## HISTORIC AND DESIGN REVIEW COMMISSION

**HDRC CASE NO:** 2016-315  
**ADDRESS:** 112 E PECAN ST  
**LEGAL DESCRIPTION:** NCB: 139 LOT: 15 NATIONAL BANK SUB UNIT-2  
**ZONING:** D RIO-3  
**CITY COUNCIL DIST.:** 1  
**APPLICANT:** Larry Gottsman  
**OWNER:** Weston Properties, LC  
**TYPE OF WORK:** Modifications to an existing monument sign  
**REQUEST:**

The applicant is requesting a Certificate of Appropriateness for approval to modify the existing monument sign at 112 E Pecan through the installation of additional signage area.

Front View - Scale: 1/2"=1'-0"

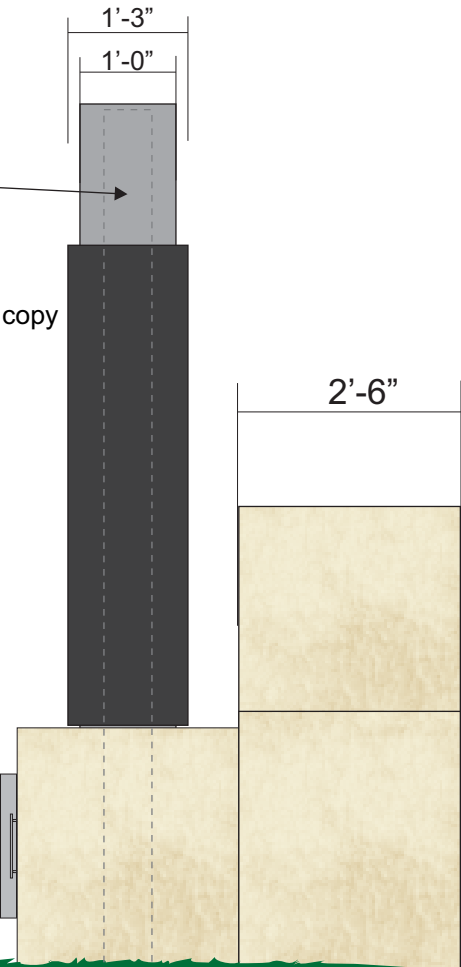
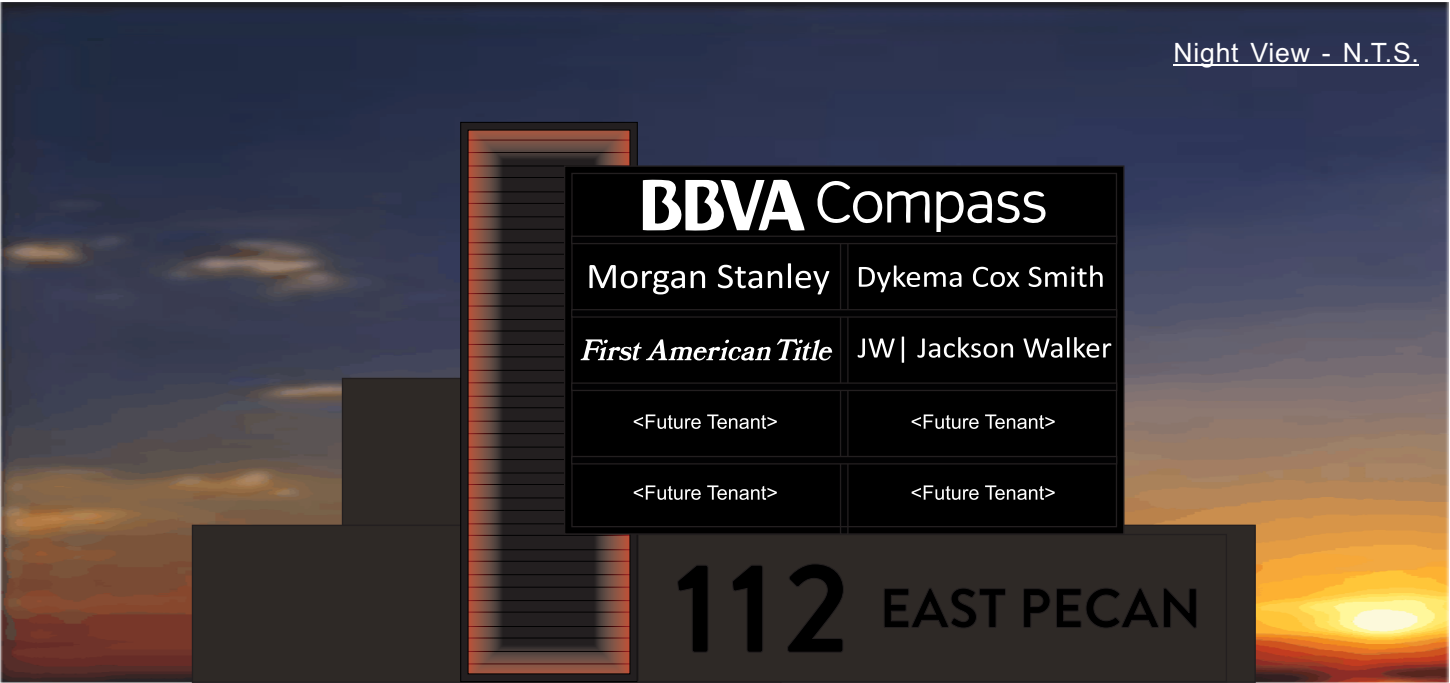
- b. The existing monument sign features three limestone veneer blocks with tenant signage. The applicant has proposed to remove signage from all three blocks and construct a new aluminum signage panel featuring approximately sixty (60) square feet in total size and signage space for nine tenants. Signage has been proposed on one side only. In addition to the proposed new signage panel, the applicant has also proposed a new vertically oriented architectural element serving as a pole cover that will feature lighting, corrugated aluminum and a height of 9' – 6" and a width of 3' – 0". Beneath the proposed signage panel, the applicant has proposed to locate the address "112 East Pecan" in all capital letters to featuring heights of 1' – 6" and 8". The applicant's proposed materials are consistent with the UDC Section 36-678(c)(3).

- c. The UDC Section 35-678 states that total signage shall not exceed fifty (50) square feet unless additional signage is approved by the HDRC. Staff finds that given the proposed location of the sign which is not visible from the

- public right of way at the Riverwalk, the overall size and massing of the primary structure on the property and the specific location of the signage in relationship to E Pecan Street that the applicant's proposed size is appropriate.
- d. The applicant has proposed to internally light the signage panel with white LED lights to be diffused by acrylic faces. The vertically oriented pole cover will feature cove lighting for its border on the front and back only. This lighting method is appropriate and consistent with the UDC Section 35-678(c)(4).

Staff recommends approval as submitted based on finding a through d.
